STAFF RECOMMENDATION

NCPC File No. 6665

OFFICE OF PERSONNEL MANAGEMENT
PERIMETER SECURITY
Theodore Roosevelt Building
1900 E Street, NW
Washington, DC

April 27, 2006

E Street Entrance Plaza: Proposed Elevation Detail

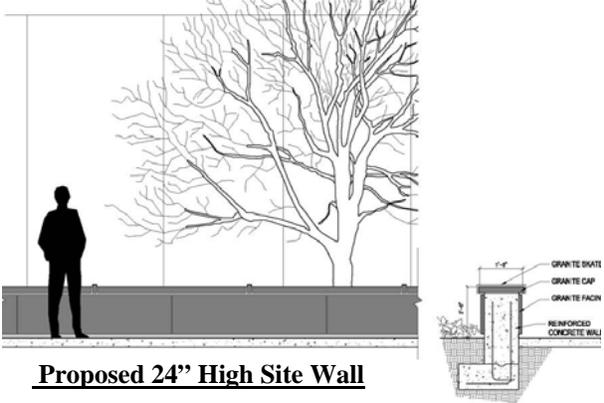
Staff recommends further design development of the E Street entrance plaza security elements in order to reduce the number of bollards. Staff suggests replacing the proposed bollards located in the green space with either benches or shifting the line of proposed plaza benches and bollards north to align with the back edge of the raised planters. Also staff recommends that the proposed entrance flag pole be hardened and integrated into the security elements.

- Replace the proposed bollards located in the green space of the north entrance plaza on E Street with benches or relocate the line of proposed plaza benches and bollards north to align with the back edge of the raised planters.

Photo Montage: Proposed Perimeter Fence along Virginia Avenue

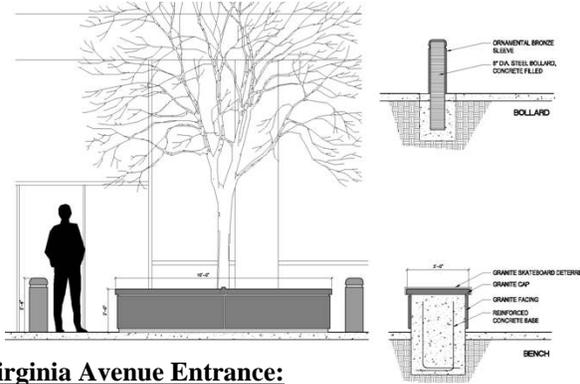
- The continuous plinth wall located along the Virginia Avenue building yard, as shown in the UDSP, has been replaced by a proposed cable reinforced perimeter fence. Staff believes that the limited disturbance for fence post installation will help preserve the existing mature trees; subsurface construction that would be required for continuous plinth walls would destroy the existing tree roots and trees. **Staff recommends that**

multiple openings be provided through the proposed perimeter fence to allow for pedestrian and employee access into the building yard. Staff recommends that the proposed reinforced benches, located on the public sidewalk and in front of the perimeter fence, be relocated off of public space and placed within the building yard.

- (C.1.6) “The placement of security barriers in public space is discouraged ...” **Staff recommends that the benches placed in front of the Virginia Avenue perimeter fence be moved off of the public sidewalk and relocated within the building yard.**

- C.2 Urban Landscape Contextual Design
 - (C.2.17) “Protection of existing trees, including their canopies and root systems ...” **Staff request further design and construction details of the Virginia Avenue perimeter fence supports in order to ensure that they will not impact the existing trees.**
 - (C.2.21) “Physical perimeter security should follow design principles to achieve a sense of openness, balance, rhythm, and hierarchy that will improve way finding and visual linkages along a street and enhance the pedestrian experience. ...” **Staff is not in favor of using perimeter security elements as a means of restricting public access to the building yard, and in particular the Virginia Avenue entrance plaza.** The proposed security elements exclusively restrict public access into the Virginia Avenue entrance plaza.

- Ensure that perimeter fence along Virginia Avenue is designed to protect the roots of existing trees.
- Replace the proposed security wall along 20th Street with a fence wall.

Virginia Avenue Building Entrance: Plan, Section & Elevations of Proposed Air-Intake Screen Walls

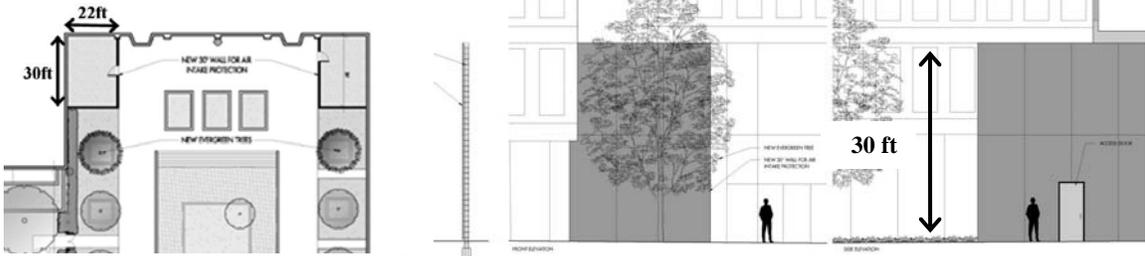
- C.1. Barrier Placement and Design
 - (C.1.4) “Protection of exterior air-intakes systems should be visually and physically integrated into the architecture of the building design. ...” The proposed 30 foot high screen walls in front of the vertical intake louvers have not been architecturally integrated into the building design and the massing appears to be additive. **Staff recommends further architectural development of the air-intake screen wall design and does not support resolving it through restricting public access into the Virginia Avenue entrance plaza.**

Staff notes that the proposed triangular raised planter bench, located in front of the line of perimeter security elements across the south entrance plaza at Virginia Avenue, is a redundant security element. **Staff recommends that the proposed triangular raised planter bench be removed and the entrance plaza remains as originally designed and open to Virginia Avenue.**

- Refine the design of the proposed air intake enclosures flanking the south entrance so that they are visually and physically integrated into the architecture of the building design.

- Modify the design of the proposed security elements crossing the south entrance plaza on Virginia Avenue to accommodate visual and public access through the use of elements such as bollards and planters, and eliminate the triangular planter.
